Access Compliance Report Public Rights-of-Way (Pedestrian Signals)

Intersection ID: N/A	Main Street:	Cross Street: N/A	Location: N/A
ADA ID: 7583F6398784	Signal Type: One Push Button-Non APS	Overall Compliance: No	Severity Score: BTN 1: N/A BTN 2: N/A No BTN: N/A
Codes/Mitigation Info/Possible Solution		Field Measurements/Component Compliance

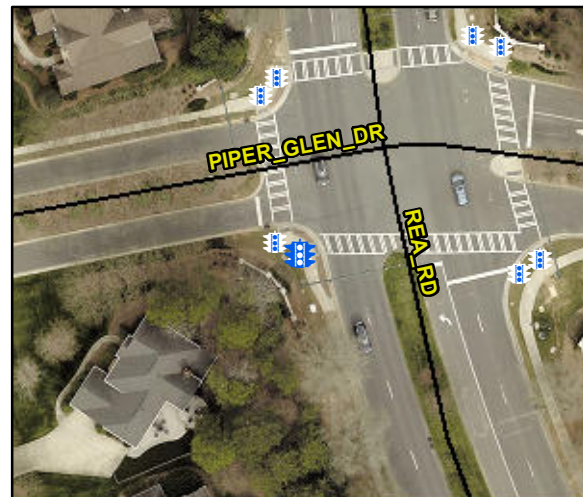
Yes	B 1 Clear Xing Direction?	ClearlyMarked	N/A	B 2 Clear Xing Direction?	N/A
	B 1 Crossing Direction	To E		B 2 Crossing Direction	N/A
Yes	B 1 DistanceTo XWalk (in)	30.0	N/A	B 2 DistanceTo XWalk (in)	N/A
No	B 1 DistanceTo Curb (in)	147.0	N/A	B 2 DistanceTo Curb (in)	N/A
Yes	B 1 Diameter (in)	2.0	N/A	B 2 Diameter (in)	N/A

Possible Solutions: Replace Signal Push Button With APS Button on New Post. Remove & Relocate Sign.
